Latency Concerns on Interleaved FEC for 100G-KR/CR

Ilya Lyubomirsky, Arash Farhoodfar, Karthik Gopalakrishnan, Jamal Riani,
Yu Liao, and Sudeep Bhoja, Inphi Corp.

IEEE P802.3ck Task Force Meeting, Jan. 2019

Interleaved FEC Latency

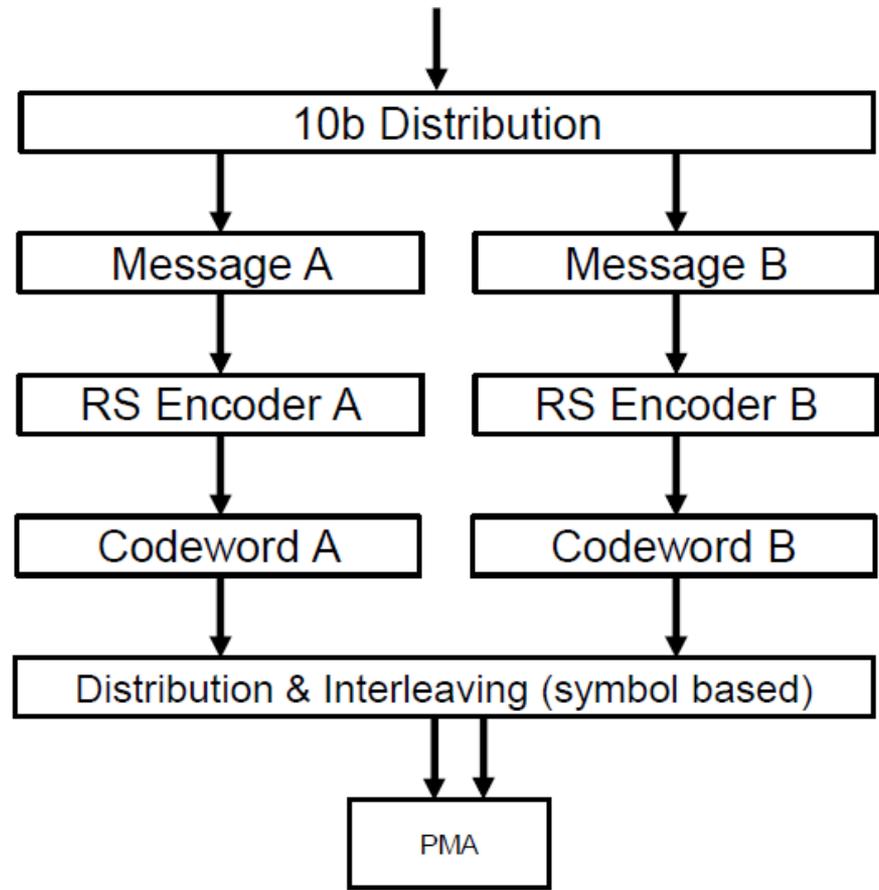
- A major disadvantage of interleaved FEC is a significant increase of the FEC latency. This may be an important issue for latency sensitive systems based on 100G-KR/CR

Latency estimate in gustlin_3ck_01_1118

Current Clause 91 RS544

Latency	Contributor
51ns	Block time
50-100ns	Processing*
101-151ns	Total

Potential RS544 Interleaved

Latency	Contributor
102ns	Block time
50-150ns	Processing*
152-252ns	Total

100G-KR Channel Simulation Results PAM4 53 Gbaud

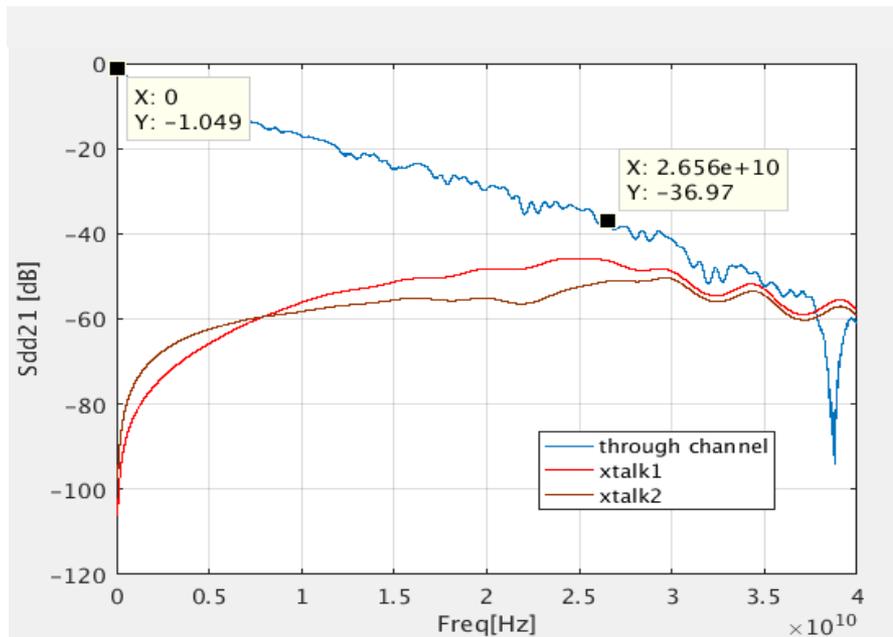
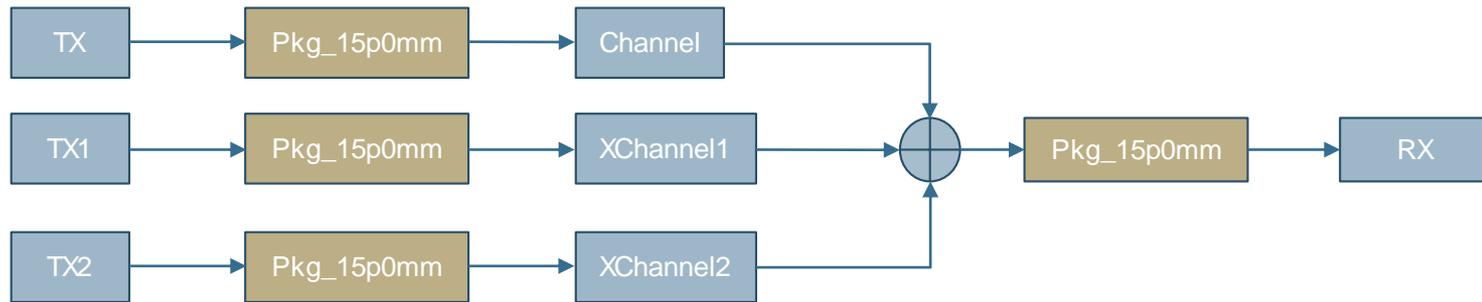
- We show simulation results for 100G SerDes that successfully closes 100G-KR link with FFE and 1-tap DFE Rx

- 15mm PKG model is cascaded at both ends of the through and cross channels.
- Total channel insertion loss $\sim 36\text{dB}$ @ Nyquist.
- TX swing = 800mV.

FFE + 1-tap DFE	Longer FFE + 1-tap DFE
BER	5.5e-4	5.5e-6
DFE Tap	0.7	0.7

- Preferable not to burden 100G-KR/CR system designs by significantly increasing FEC latency with interleaved FEC
- Alternative solutions exist by imposing constraints on DFE tap values and/or implementing Rx architectures which are not prone to burst error problems
- More work is needed before making a decision on adopting interleaved FEC for 100G-KR/CR
